## MEMORANDUM

To: Development Review Board  
From: Mary O'Neil, AICP, Principal Planner  
Date: May 2, 2023  
RE: ZAP-23-2; 410 North Street

**File:** ZAP-23-2

**Request:** Appeal of ZP-23-80: Administrative denial to convert existing single family home with detached ADU/garage to a duplex via roof extension. Administratively denied March 20, 2023.

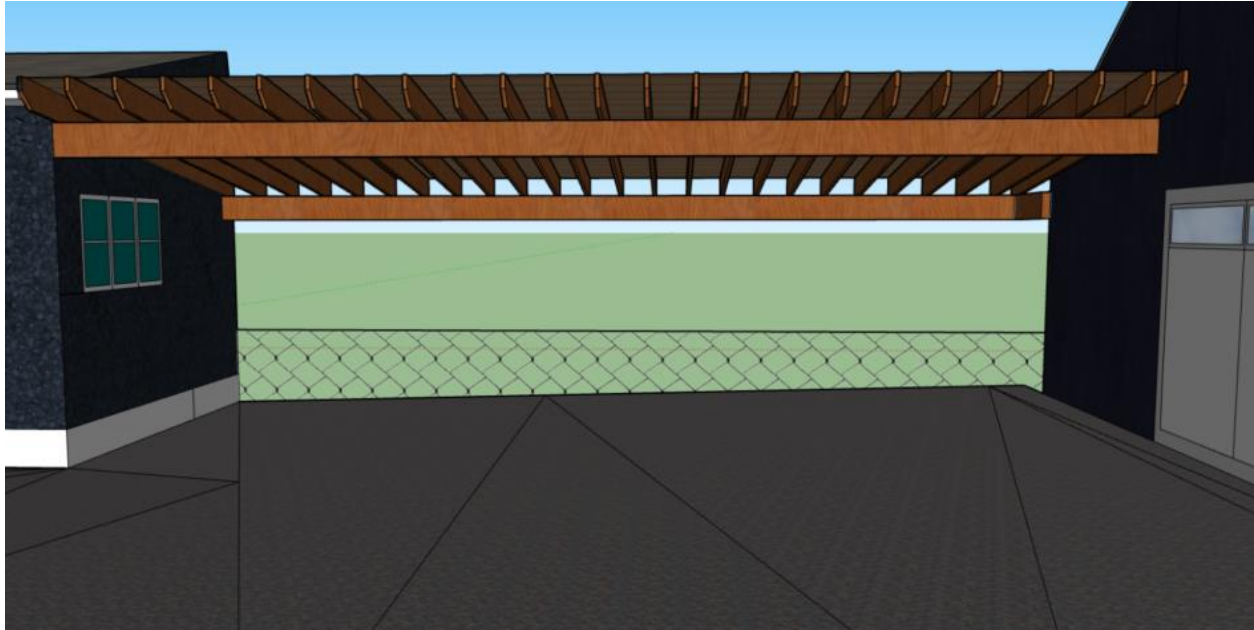
The proposed connector is a set of parallel roof joists, presenting rafter tails which extend into the required side yard setback. A minimum 2.7’ setback is required, 10% of the lot width at the point of the development. They are poised approximately 1.3’ from the side property line.

Rafter tails do not meet the definition of Eave (see below), and as a largely open structure, not a solid or boxed roof overhang.

**Adverse finding** for interpretation as Eave. The roof is not a solid plane, but the exposed and projecting rafter tails might be determined to be a “roof overhang.” This interpretation is at the discretion of the DRB.

The structure may find difficulty in securing a building permit with the proximity to a property line, as shelters for vehicles typically include consideration of combustability; requiring greater setbacks to meet life safety code. The applicant is encouraged to consult a building official.
